SHEET NAME
EROSION CONTROL DETAILS 1

BRADLEY CROSSROADS LOT 4A

1830 MAIN STREET
COLORADO SPRINGS, CO

PROJECT STATUS
PERMIT REVIEW

- DDP10.05

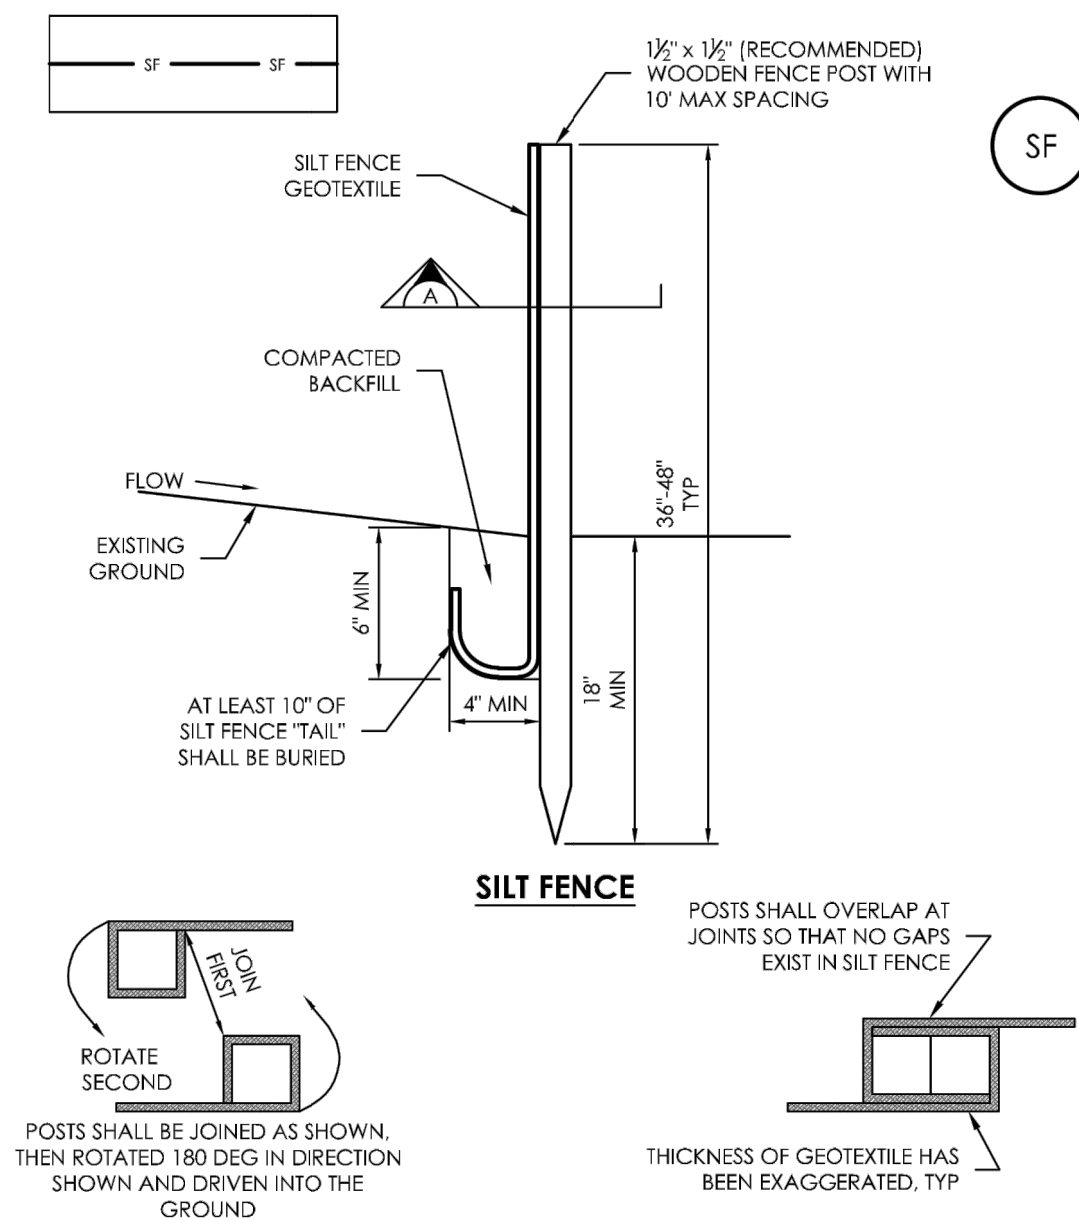
Please add detail for pond modifications to the GEC plan
